Access Compliance Report

Public Rights-of-Way

Intersection ID: 11207	Main Street: GRANDIN_RD	Cross Street: W_4TH_ST	Location: S
ADA ID: FEC2F81A3EBE	Ramp Type: Perp	Initial Pass/Fail: Fail	Overall Compliance: No
			Severity Score: 8.75

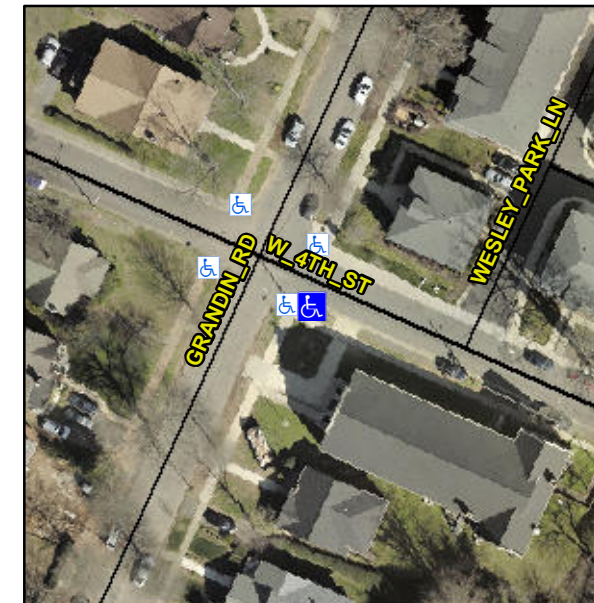
Not Found, R304.5.1

Compliance	Description	Data	Compliance	Description	Data
N/A	Ramp Length (in)	49.0	Yes	Ramp Slope (%)	5.0
No	Ramp Width (in)	44.0	Yes	Ramp XSlope (%)	2.0
N/A	Flare Type LT	N/A	N/A	Flare Type RT	N/A
N/A	Flare Slope LT (%)	N/A	N/A	Flare Slope RT (%)	N/A
N/A	Flare Traversable LT?	N/A	N/A	Flare Traversable RT?	N/A
N/A	Landing Length (in)	N/A	N/A	DWS Provided?	N/A
N/A	Landing Width (in)	N/A	N/A	DWS Contrast?	N/A
N/A	Landing Slope (%)	N/A	N/A	DWS Length (in)	N/A
N/A	Landing X Slope (%)	N/A	N/A	DWS Full Width?	N/A
N/A	Landing Curb? (Y/N)	N/A	N/A	DWS Offset (in)	N/A
N/A	Shared Landing?	N/A			
N/A	Gutter Ponding?	N/A	N/A	Gutter Slope (%)	N/A
N/A	Gutter Lip Ht (in)	0.5	N/A	Gutter X Slope (%)	N/A
N/A	Painted X Walk1?	No	N/A	Painted X Walk2?	N/A
	X Walk 1 Direction	To NE		X Walk 2 Direction	N/A
N/A	X Walk 1 Width (in)	N/A	N/A	X Walk 2 Width (in)	N/A
	X Walk 1 Slope (%)	2.0		X Walk 2 Slope (%)	N/A
	X Walk 1 X Slope (%)	1.4		X Walk 2 X Slope (%)	N/A

Remove & Replace Entire Ramp.
